Your Ref: RNP/ABW/H1419075
Our Ref: qA1316455 / R0026
Date: 06 March 2020

**A40 LLANDDEWI VELFREY TO PENBLEWIN IMPROVEMENTS
MARGARET RHIAN THOMAS,**

Figure 1: Major and Minor Flow projections (2036 projections) onto Figure 2/2 of TD42/95

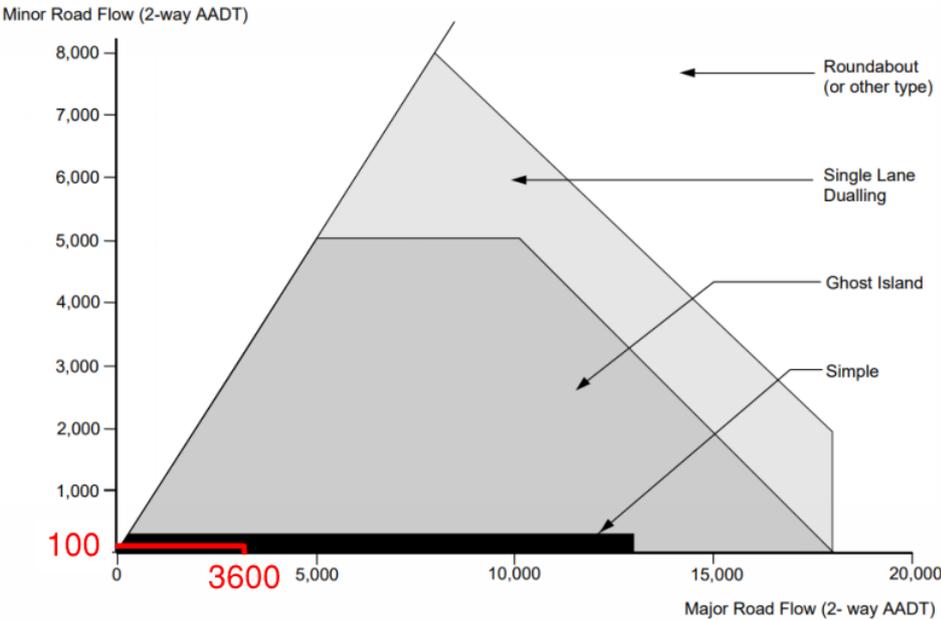
4. The A478 should have a central reservation area for vehicles turning from the A478 into the new Trefangor Lane

4.1 There is no proposal to provide a turning area for vehicles turning right from the A478 into Trefangor Lane. The predicted vehicle movements in and out of Trefangor Lane do not justify a turning area (known as a ghost island) to be provided on the A478.

4.2 Traffic along highways is generally measured as Annual Average Daily Traffic (AADT). An analysis of the likely agricultural vehicle movements along Trefangor Lane has been undertaken and the 2-way AADT is shown to be well below 50. A conservative estimate of the likely total vehicle movements (i.e. agricultural vehicles and private vehicles) is 100 AADT.

4.3 The design standards for the Geometric Design of Major / Minor Priority Junctions is outlined in TD42/95 of the Design Manual for Roads and Bridges (DMRB). Figure 2/2 of this standard provides guidance on the approximate priority junction provision on single carriageway roads based on traffic flows. This diagram shows that simple T-junctions are an appropriate level of provision where the Major Road AADT is up to 13,000 and if the Minor Road AADT is up to 300. For the proposed Scheme, the projected traffic figures for both the Major Road (the A478) and the Minor Road (Trefangor Lane) fall well within the traffic figures outlined. This is shown by the red lines on Figure 1.
